**TOWN OF NEWBURGH
PLANNING BOARD
TECHNICAL REVIEW COMMENTS**

PROJECT: KOLB RADIOLOGY
PROJECT NO.: 19-18
PROJECT LOCATION: SECTION 75, BLOCK 1, LOT 19.15
REVIEW DATE: 13 AUGUST 2019
MEETING DATE: 15 AUGUST 2019
PROJECT REPRESENTATIVE: MAURI ARCHITECTS

1 PROPOSED SITE PLAN
SCALE: 1" = 20'-0"

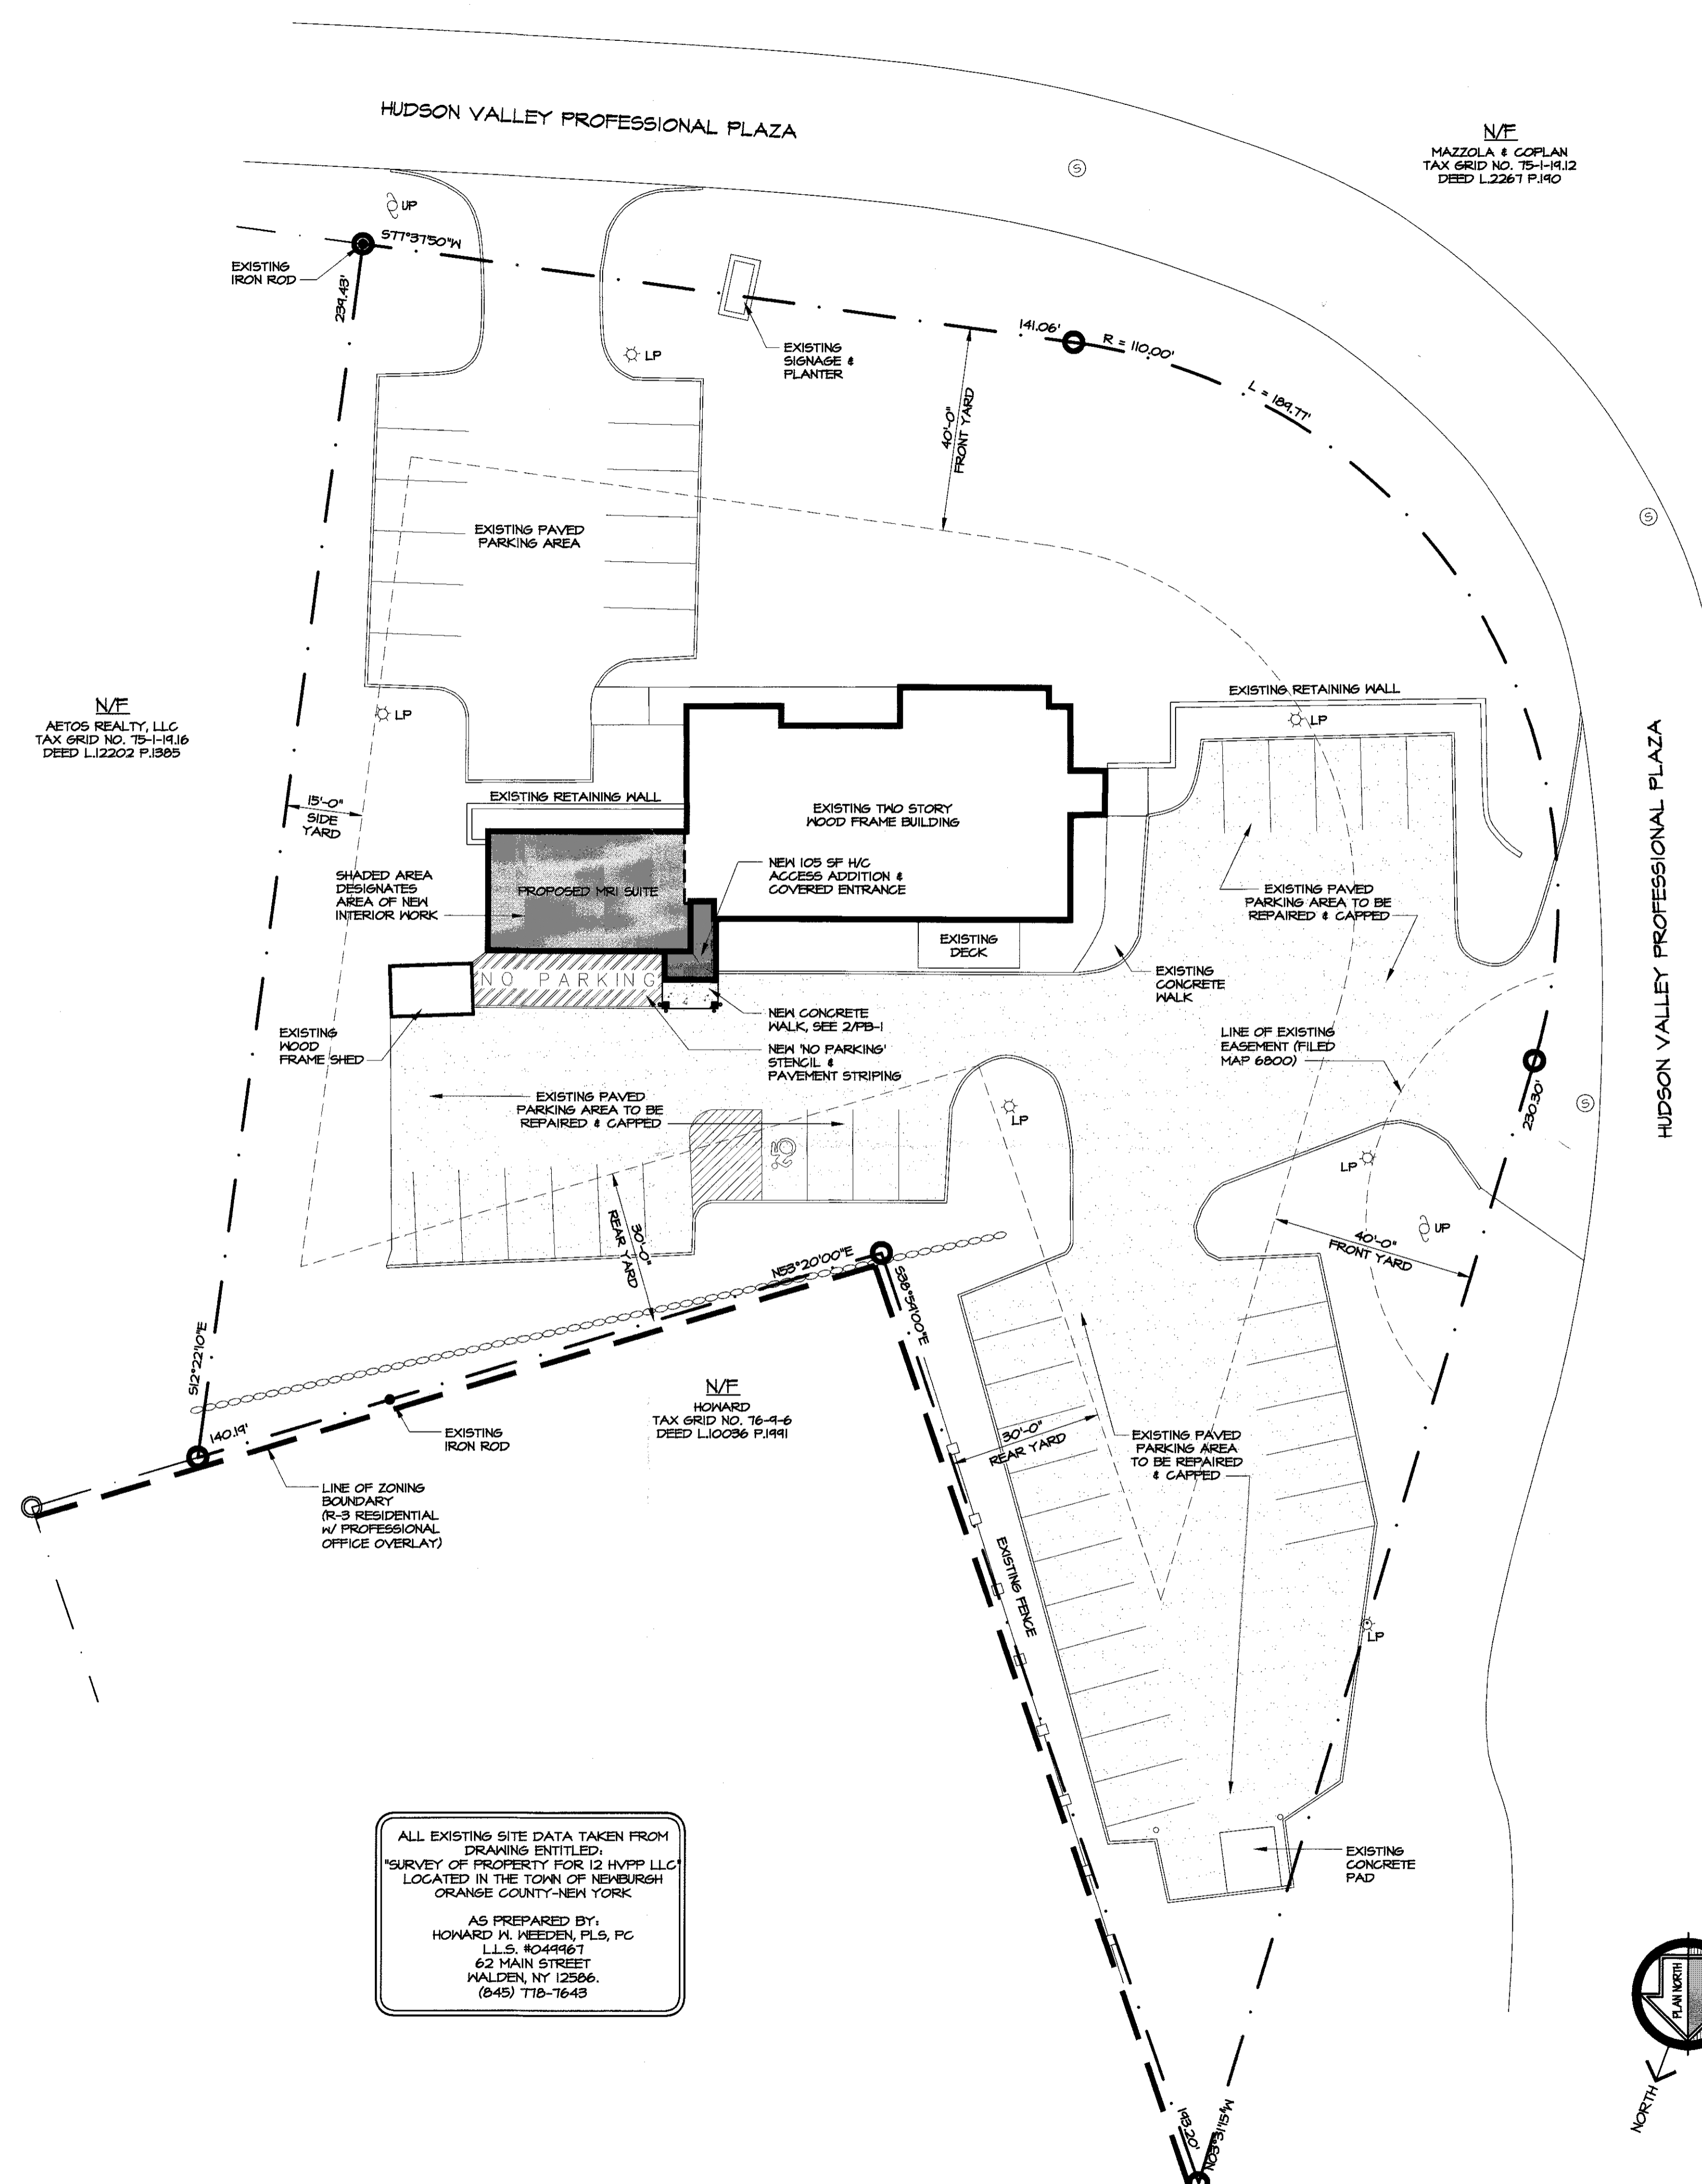
2. The proposed pavement details should be detailed on the plans.
3. Stripping details compliant with Newburgh double stripe details should be added to the plans for re-stripping of the re-surfaced parking lot.

4. One accessible parking space is depicted. The Applicants are requested to evaluate whether additional accessible parking spaces are required based on proposed use and number of spaces on the site.

7. The project is located to a lot which adjoins the R-3 Zone with a professional office overlay. A heavily wooded tree line exists between this site and the residences on Blue Jay Drive. The Planning Board should determine if this existing buffer is adequate for compliance with the Town's buffer requirements between the B Zone and R-3. It is noted that gaps exist in the tree line.

9. Information on any proposed additional site lighting should be depicted on the plans.
10. The existing dumpster enclosure is in disrepair and is located a significant distance from the professional office in the vicinity of the residential structures on Blue Jay Drive. The Applicants are requested to evaluate re-construction of the dumpster and possible re-location of the dumpster to the vicinity of the shed closer to the structure.
11. The Applicants representative are requested to evaluate existing landscape conditions. It appears the landscaping has matured over time to be significantly higher than the gutter lines along the building frontage.
12. Existing bollard lighting is not depicted along the building frontage. The existing bollard lighting will be impacted the proposed addition.
